Meshreen Technology Ltd.

Due to the business consideration, we hereby declare that our product of JN5168 High Power ZigBee Module with u-FL connector/JN5168 Hight Power ZigBee Module with embedded antenna

Model: MS5168-M04 have as following difference

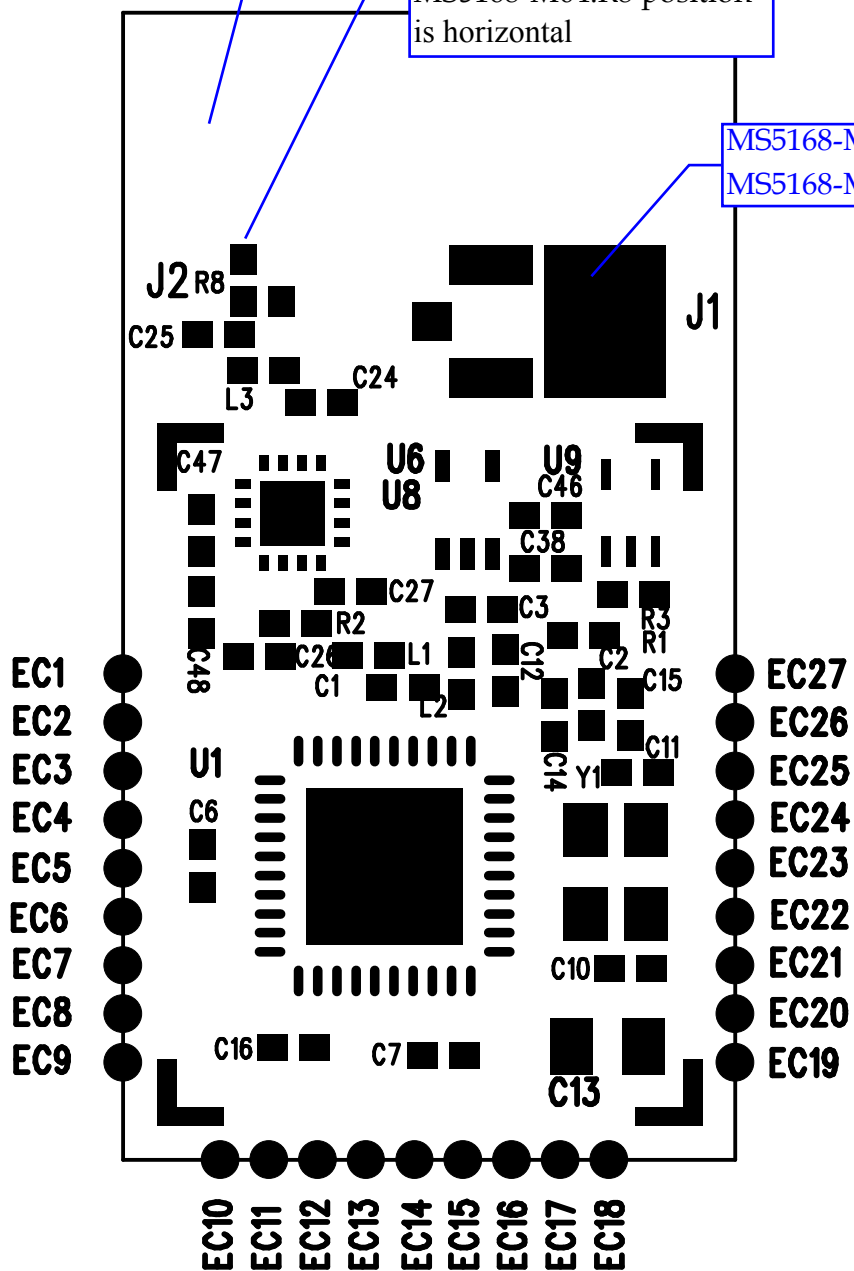
MS5168-M05 uses PCB antenna. MS5168-M04 uses external antenna (u-FL connector). MS5168-M05 resistance (R8) position is vertical. MS5168-M04 resistance (R8) position is horizontal. J1 element is not in MS5168-M05. J1 element connects to external antenna in MS5168-M04.

MS5168-M05: with PCB antenna
MS5168-M04: use external antenna with
J1 u-FL connector

MS5168-M04:R8 position
is vertical.

MS5168-M04:R8 position
is horizontal

MS5168-M04: J1 is not included.
MS5168-M04: J1 is included.
